PEQUONNOCK RIVER TRAIL

STATE PROJECT NO. 144-186
TOWN OF TRUMBULL

ADDENDUM NO. 2

PROJ. No.: 20070072.A10	CD-505
DATE: APRIL 2013

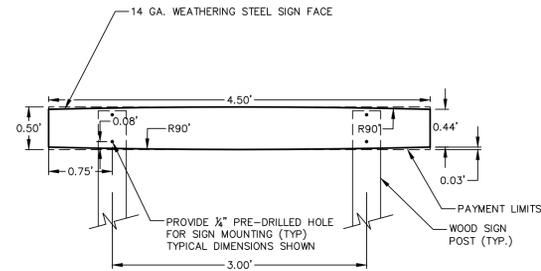
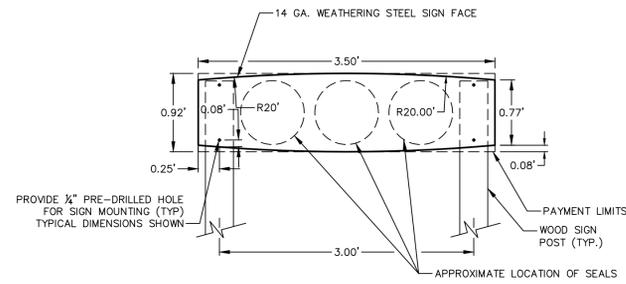
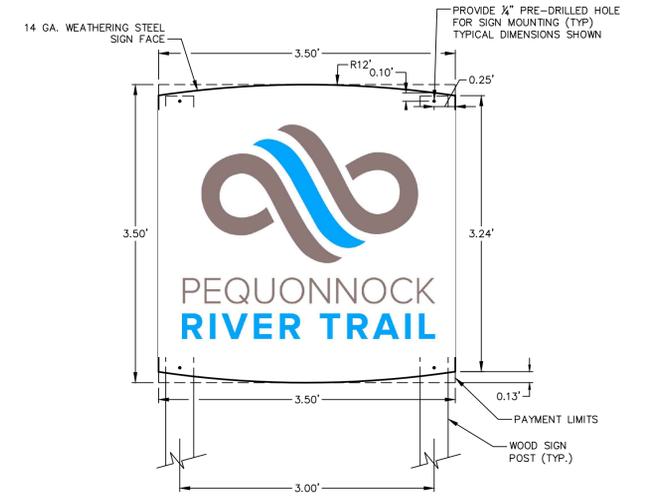
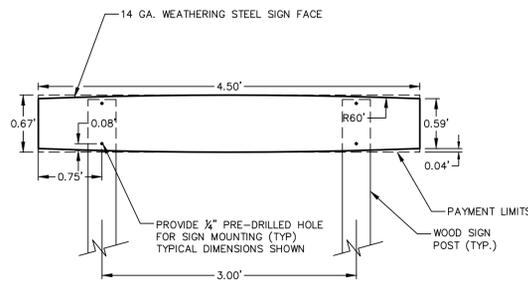
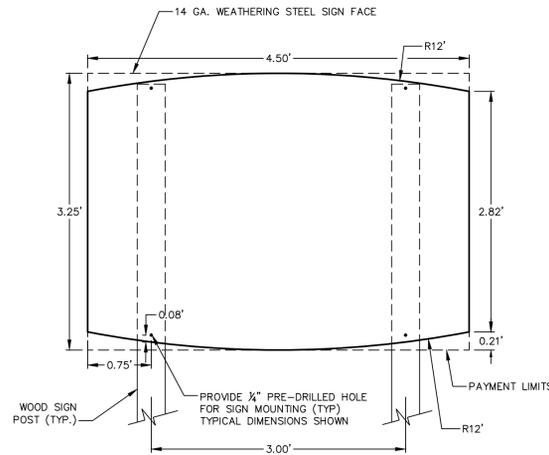
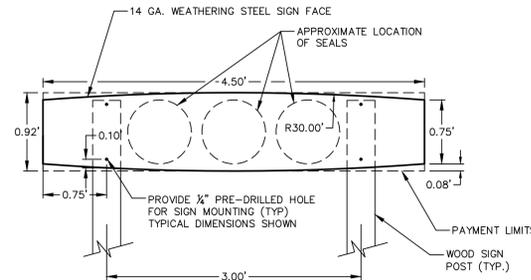
REVISIONS		PROJ. MANAGER:	SEAL
No.	DATE	DESCRIPTION	BY
1.	05/2013	CLARIFY PAY ITEM DESCRIPTION	MSR

PROJ. No.: 20070072.A10
 DATE: APRIL 2013
CD-507

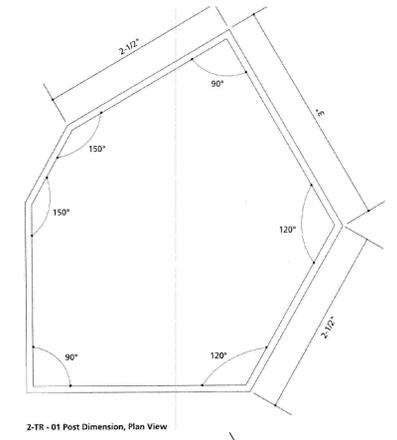
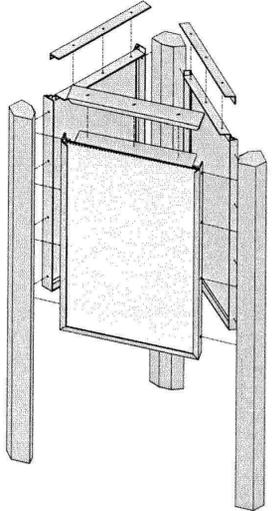
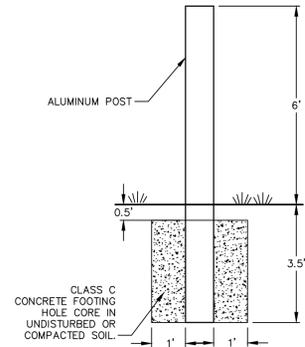
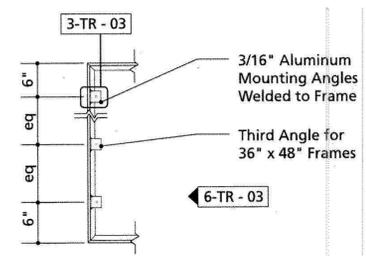
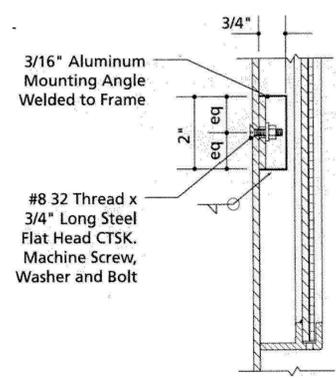
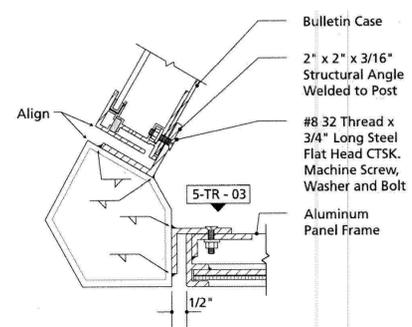
Q2. Is there a prefabrication for the type II kiosk? What specific manufactured material is to be used for construction?

A2. The Contract Specifications read, “Trail Head Kiosk – Type II shall be a complete manufactured system, including posts, frames, hardware and appurtenances, complying with the

United States Department of the Interior, National Park Service UniGuide Sign Standards for upright tri-sided aluminum sign frame and will be sized to accommodate 24" x 36" sign faces."

We have not specified a specific manufacturer. It is expected that there are firms that manufacture this sign type. The materials to be used in the fabrication of the sign is indicated in the details on Sheet CD-507. Also a reference for the National Park Service is provided for further information.

PROJ. No.: 20070072.A10
 DATE: APRIL 2013
SA-106

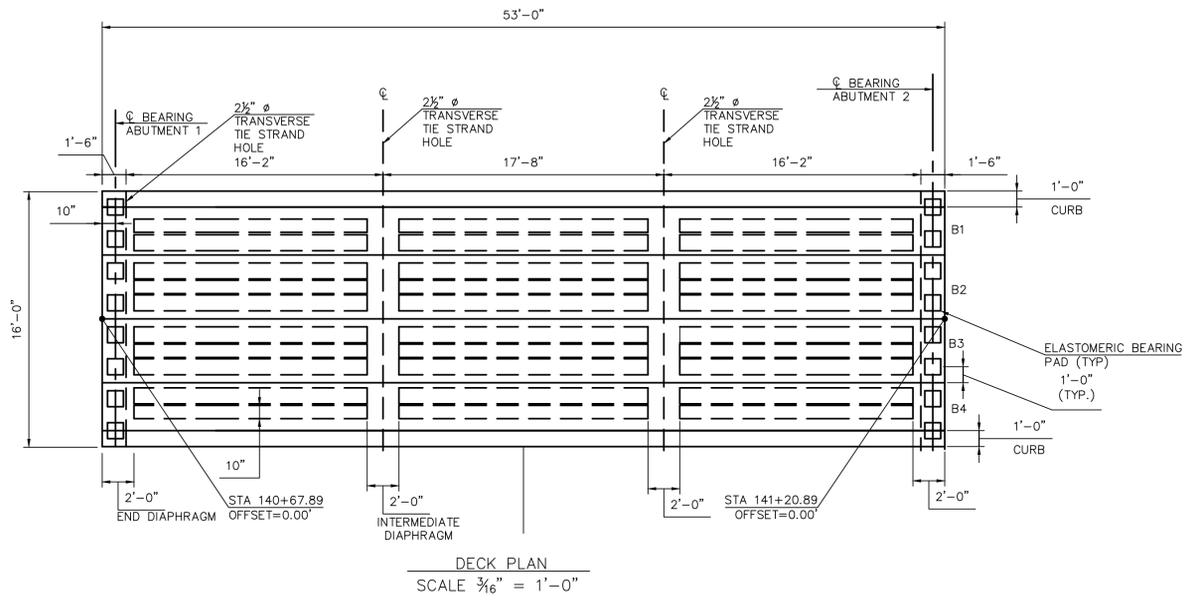
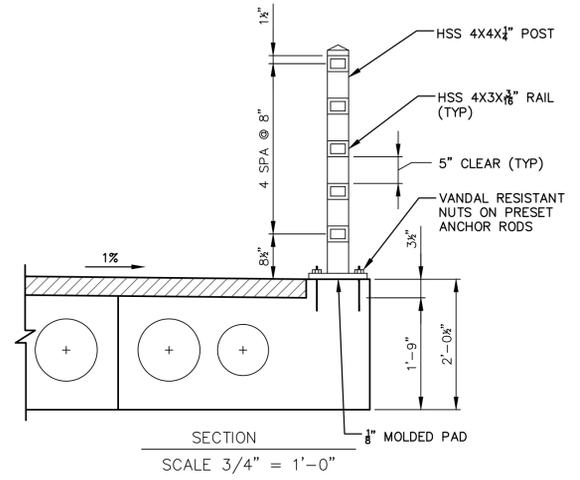
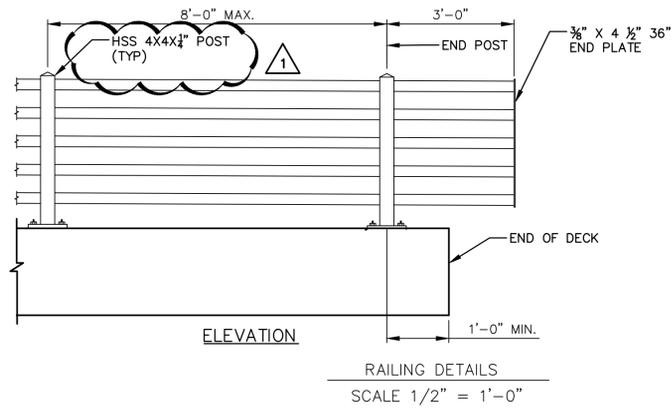
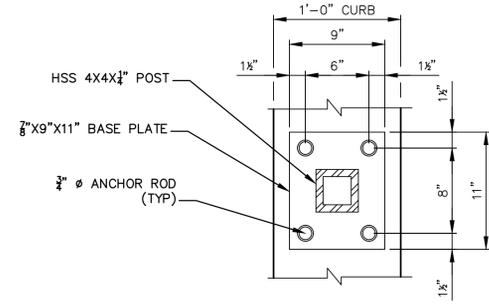
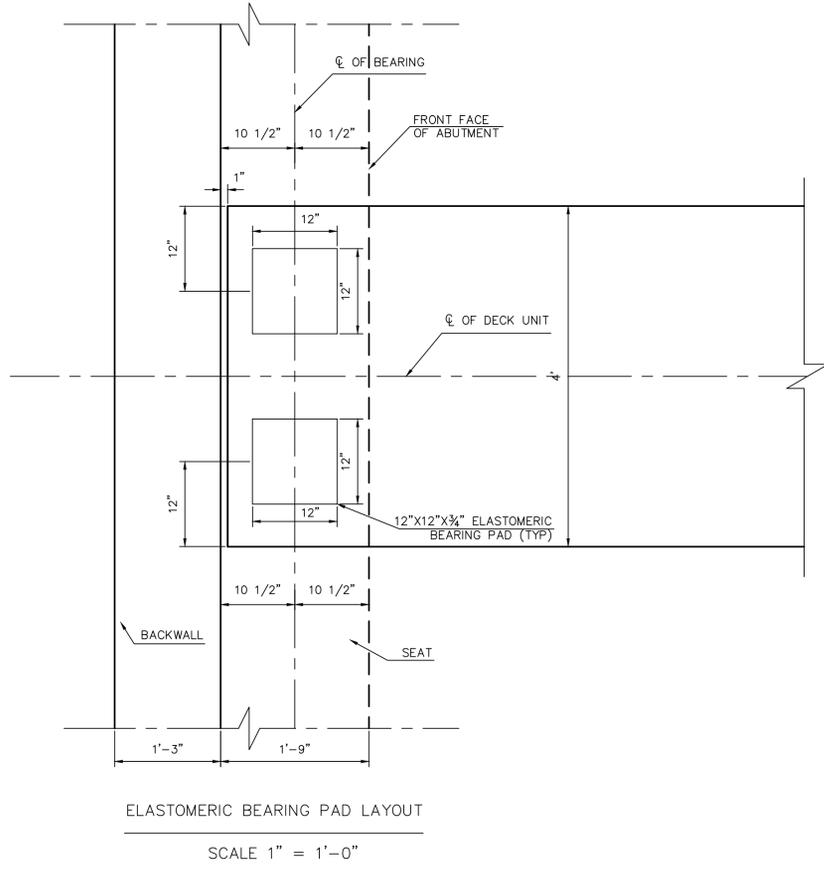
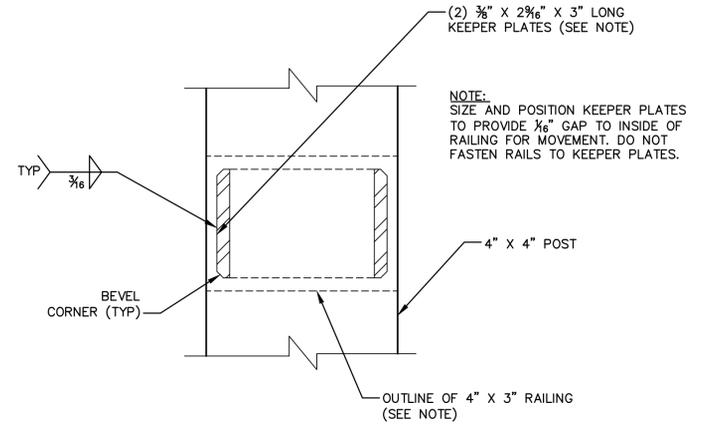
Q5. In regards to the proposed railings for the proposed bridge, the railing on the plans are showing HSS 3-1/2" x 3-1/2" x 1/8" post and the base plate detail on the plans is showing HSS 4" x 4" x 1/4" post. Which size is correct?

No.	DATE	REVISIONS	DESCRIPTION	MSR	BY
1.	05/2013		REVISED RAILING POST SIZE

A5. The correct size of the post is HSS 4"x4"x1/4".
